ORDER FOR MODIFICATION OF LICENSE

SAFETY EVALUATION REPORT

VERMONT YANKEE NUCLEAR POWER STATION

OPERATION WITH PLUGGED BYPASS FLOW HOLES

FIGURE 2  
AVERAGE PLANAR EXPOSURE (MWD/IT) - MAXIMUM ALLOWABLE PLANAR L HGR

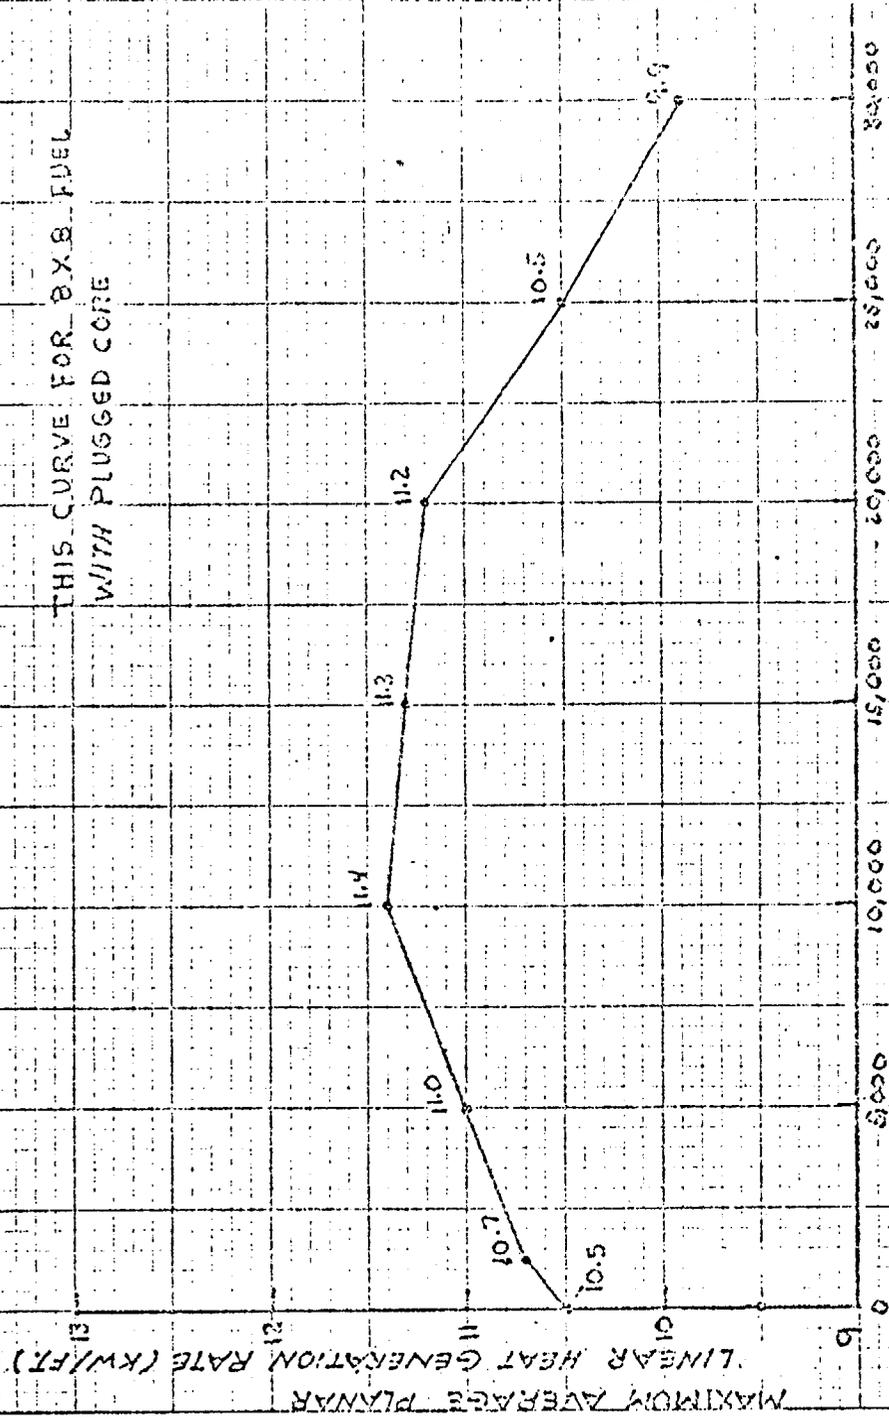
We modified the 8x8 type fuel MAPLHGR curve, Figure 2, using as a basis the most recent analytical methods in the licensee's submittal of July 30, 1975.

There are two limitations on the continued operation of the reactor for the remainder of this fuel cycle. These are the limiting assembly maximum average planar linear heat generation rate, MAPLHGR, and the minimum critical power ratio limit related to boiling crisis, MCPR. Operation shall conform to a MCPR value of equal to or greater than 1.28 as proposed by the licensee. The limiting value of MAPLHGR included with the proposed Technical Specifications submitted on October 31, 1974 have been revised to account for the staff requirements of December 27, 1974 and the proposed operation with plugged bypass holes. The revised values are given in Figures 1 and 2 for Generic B 7x7 Fuel and 8D219 8x8 Fuel types. A maximum value linear heat generation rate of 13.4 kw/ft for 8x8 fuel shall remain in effect until the Commission completes its review of the licensee's proposed increase in linear heat generation rate.
